M9018B-03

Information Only Service Note

M9018B PXIe Chassis: 18-slot, 3U, 8 GB/s

Code 10 errors under Device Manager for PCI Express to PCI/PCI-X Bridge when use with M9025A.

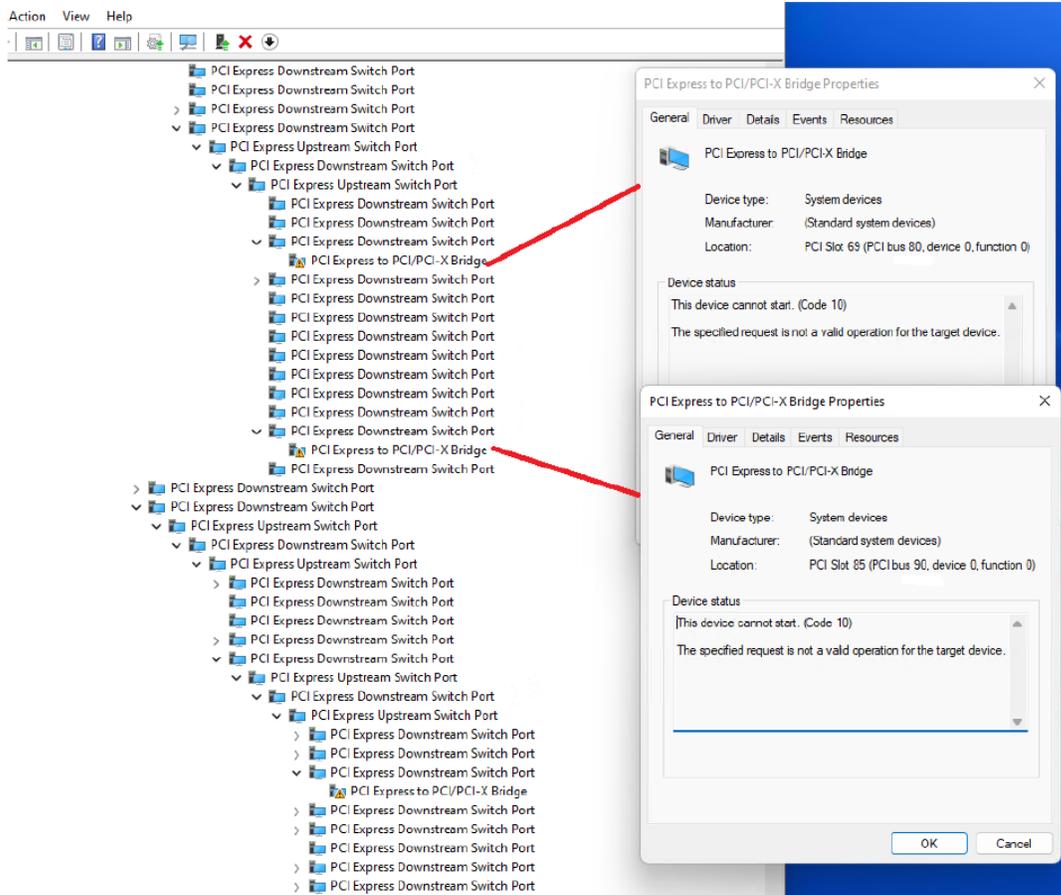
It has been found when the affected chassis are used with M9025A PXIe Thunderbolt System Module that the Device Manager would encounter code 10 errors under the PCI Express to PCI/PCI-X Bridge like picture below.

Follow the steps below to resolve the code 10 errors at the PCI Express to PCI/PCI-X Bridges.

1. Install drivers version 1.7.913.1 or later at the chassis product website <http://www.keysight.com/find/M9018B>, navigate to Technical Support > Drivers, Firmware and Software > PXIe Chassis Family Drivers.
2. After updating the drivers, run the update FW tool at the chassis product website <http://www.keysight.com/find/M9018B>, navigate to Technical Support > Drivers, Firmware and Software > Chassis Firmware.
 - a. When the *.bin file is run, it will detect the PXI-X switch Firmware needing to be updated like picture below. Press Update to update.
